TO: Mercedes-Benz Dealer Principals, General Managers, Sales Managers, Service Managers, Parts Managers	FROM: Anthony Washington, Department Manager, Regulations and Certifications
Re: Service Campaign Notification Model 907 (Sprinter) Model Year 2021 Retrofit Door Control Module	DATE: July, 2022

Campaign No. 2022060004 July, 2022

SUBJECT: **Model 907 Model Year 2021
Retrofit Door Control Module**

D72.29-1129-76

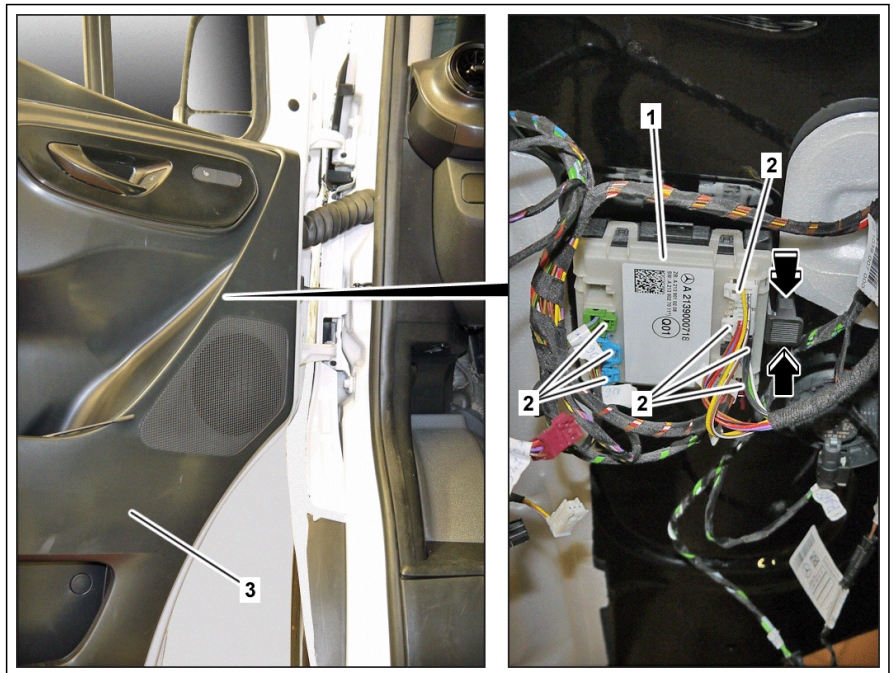
◀	Check		
1	Check whether vehicle is affected by measure.	If the vehicle already has a door module, close the campaign using 02-0001 op Code for inspection only. 0.1hr	SM72.29-D-0016SG SM72.29-D-0016-01AAB
↕	Remove		
2 AR	Remove door trims (3) of right and left front door.	<p>i</p> <p>When removing, check whether all retaining clips or covers, screws, etc. are present, If not present, ↓ determine and order required parts using XENTRY Parts Information.</p>	AR72.10-D-6575TS
↕	Install		
3 AR	Retrofit control units (1) of both front doors.	<p>i</p> <p>Clip control units (1) into holders and lock (arrows).</p>	AR72.29-D-1001TS
4	Connect electrical connectors (2).	<p>i</p> <p>The number of electrical connections (2) may vary depending on vehicle equipment.</p>	
5 AR	Install door trims (3) of right and left front door.		AR72.10-D-6575TS
